Proposal for Supplement 15 to Regulation No. 50 (Position, stop, direction indicator lamps for mopeds and motorcycles)

Note: The text reproduced below was prepared by the expert from the International Motorcycle Manufacturers Association (IMMA) in order to change the inward visibility angle of front position lamp in Regulation No. 50. The modifications to the current text are marked in bold or strikethrough characters.

- Annex 1. Minimum horizontal (H) and minimum vertical (V) angles for spatial light distribution

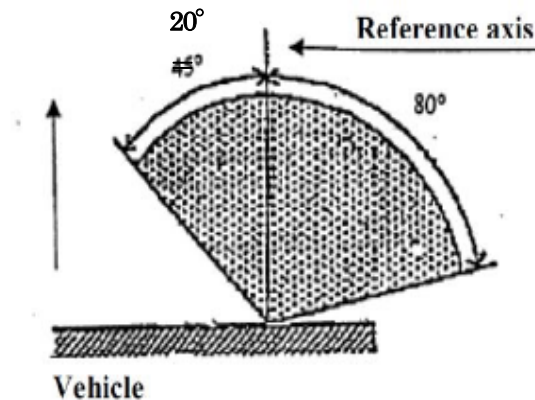
Front position lamps (for a pair of lamps)

V = + 15 degrees / - 10 degrees

- Following the approvals of "deletion of stipulation that prohibits 'combined' and 'reciprocally incorporated' of the direction indicator lamp (R53)" as a result of 152nd WP29 and "addition of amber to the colours of the front position lamp (R50, R53) as a result of 153rd WP29, reciprocal incorporation of the direction indicator lamp and front position lamp were made possible. However, because the horizontal visibility angle of the pairing front position lamp is 45 degrees inwards, which is different from that of the indicator lamp (20 degrees), we propose that the horizontal angle of the front position lamp should be 20 degrees inwards to conform to that of the direction indicator lamp
- IMMA proposes to amend Regulation No. 53 for the same reason.
